A d d e n d u m

Jones County

C.O.	Proposal ID	Proposal Work Type	County	Project Number	Addendum
		Building Construcion	JONES	M-0427	001

ANAMOSA STORAGE BUILDING RECONSTRUCTION & ADDITION

SHEET
001

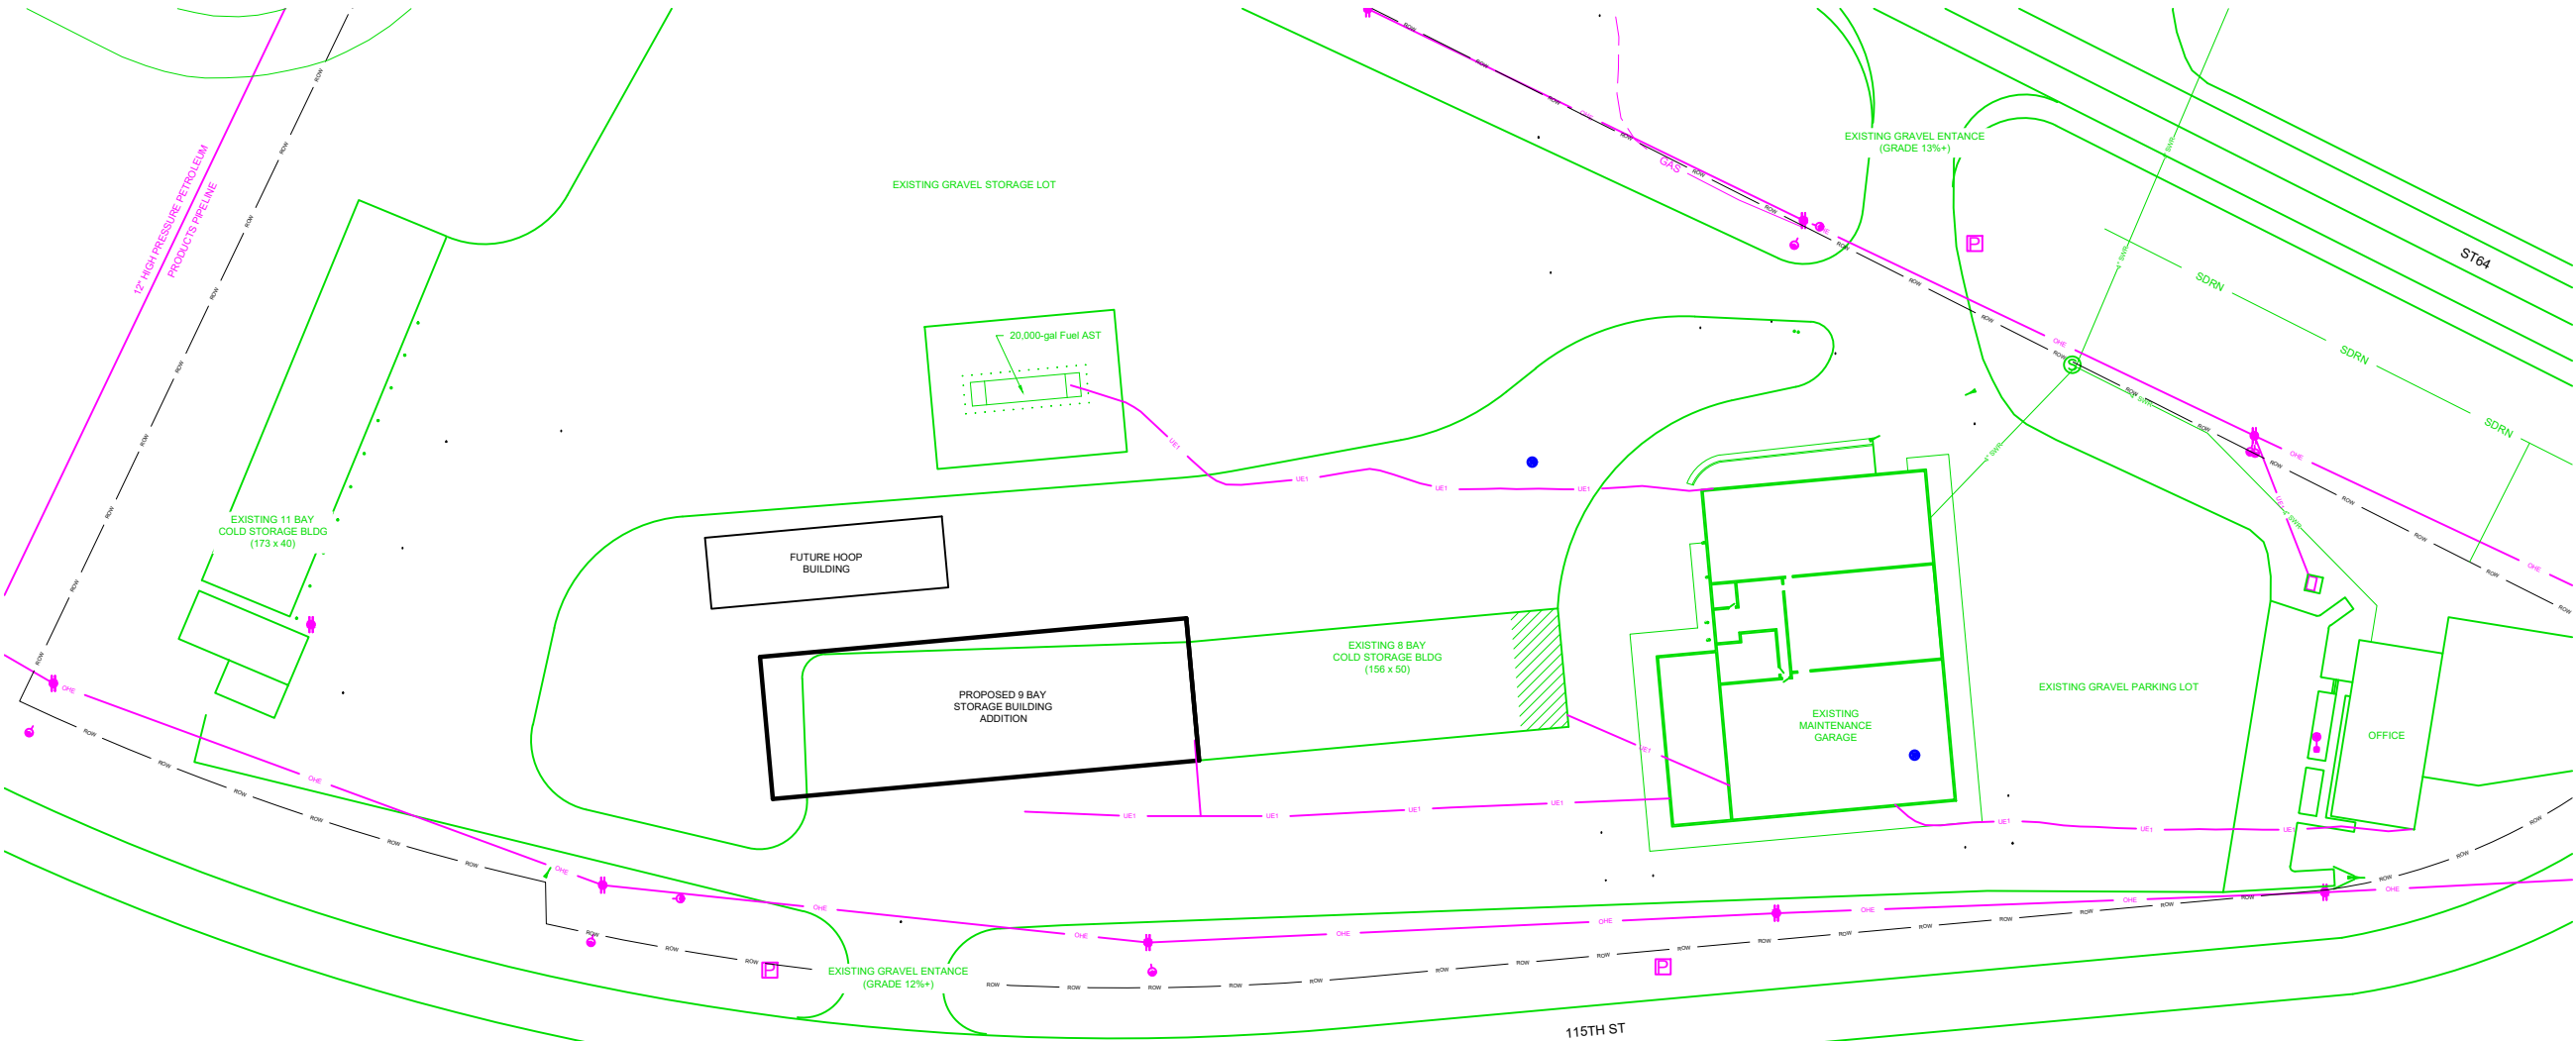
Edit Reconstruction & Addition Project note #6.

- RECONSTRUCTION & ADDITION PROJECT INCLUDES:**
1. REMOVING METAL SIDING AND ROOFING MATERIALS FROM EXISTING COLD STORAGE BUILDING.
 2. REMOVING FURTHEST EASTERLY BAY IN ITS ENTIRETY FROM EXISTING COLD STORAGE BUILDING.
 3. CONSTRUCT CONCRETE FOUNDATION AND SLAB FOR 9 BAY STORAGE ADDITION.
 4. FURNISH AND INSTALL NEW 9 BAY STORAGE BUILDING ADDITION.
 5. INSTALL NEW INSULATED EXTERIOR METAL WALL AND ROOF PANELS ON EXISTING COLD STORAGE BUILDING.
 6. INSTALL 16 NEW INSULATED OVERHEAD SECTIONAL DOORS ALONG SOUTHERN FACING WALL AND 2 ~~ALONG EASTERN FACING WALL~~ ENTRY DOORS (ONE ON EACH END OF THE BUILDING).
